Proposal for a new series of amendments to Regulation No. 118 (Burning behaviour of
Materials)

A. PROPOSAL

Example 2

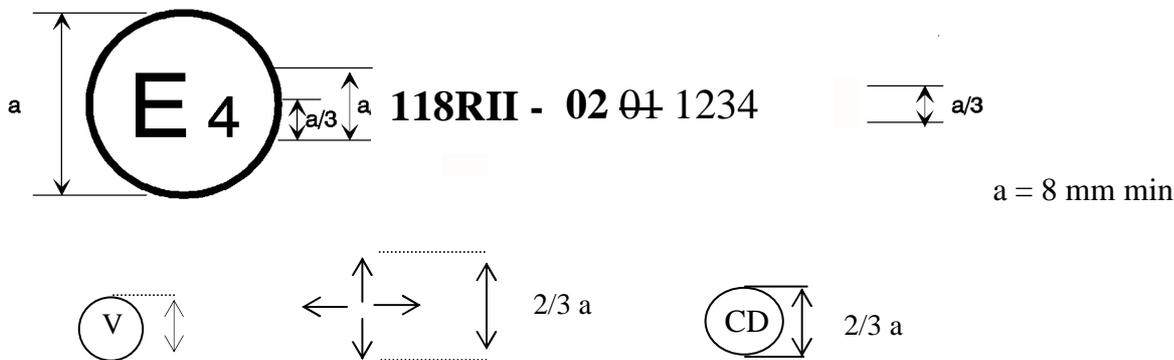
The above approval mark affixed to a component shows that the type concerned was approved in the Netherlands (E4) pursuant to Part II of Regulation No. 118 under approval number 01 021234. The first two digits (01 02) of the approval number indicate that the approval was granted in accordance with the requirements of the 01 02 series of amendments to Regulation No. 118.

Figure 1
Specimen holder
(Dimensions in millimetres)

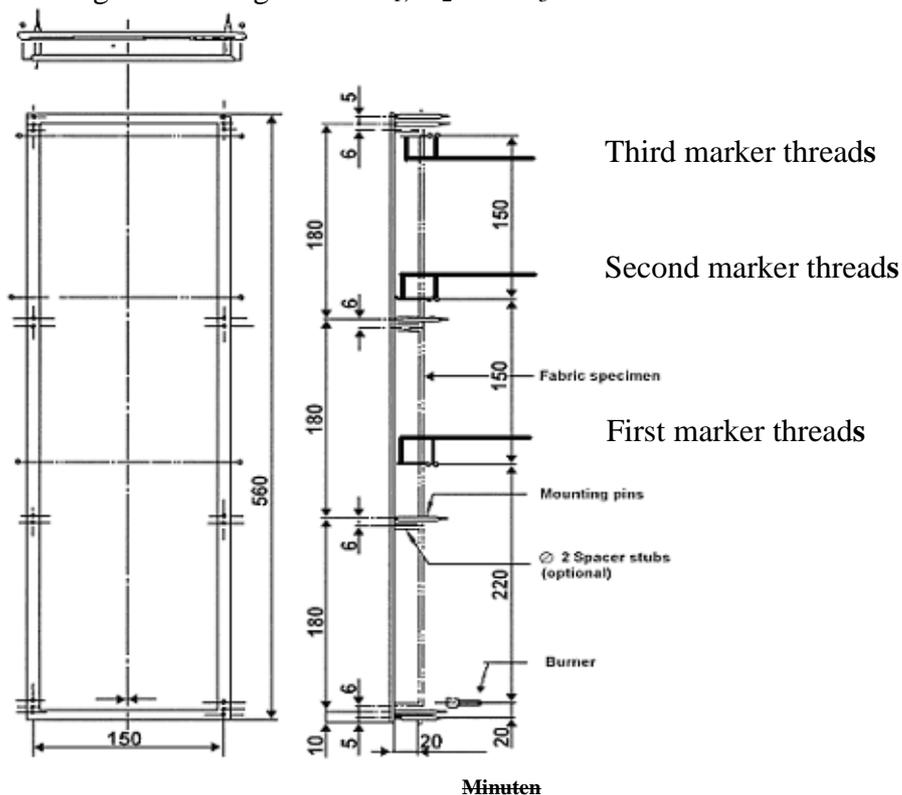
- 4.4. The marker threads shall be attached horizontally in front **of and behind** of the specimen at the locations shown in figure 1. At each location, a loop of thread shall be mounted so that the two segments are spaced 1 mm and 5 mm from the **front and rearface** ~~plane of the front~~ of the specimen.
Each loop shall be attached to a suitable timing device. Sufficient tension shall be imposed to the threads to maintain ~~its~~ **their** position relative to the specimen.
